RESPONSE LETTER NO. 3 TO REQUEST FOR INFORMATION

Project Title: Roadway Improvements to NW 37th Avenue from NW 36th Street to NW

79th Street

Project No.: 20210093 (Capital)

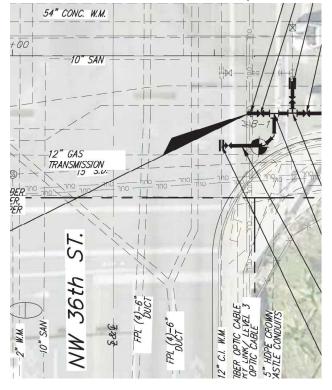
33) Vol 5- WASD WM PLANS, PDF page 38 shows start of work at Sta 20 51 with a 12" tap, does the work at this location requires DOT full intersection restoration?
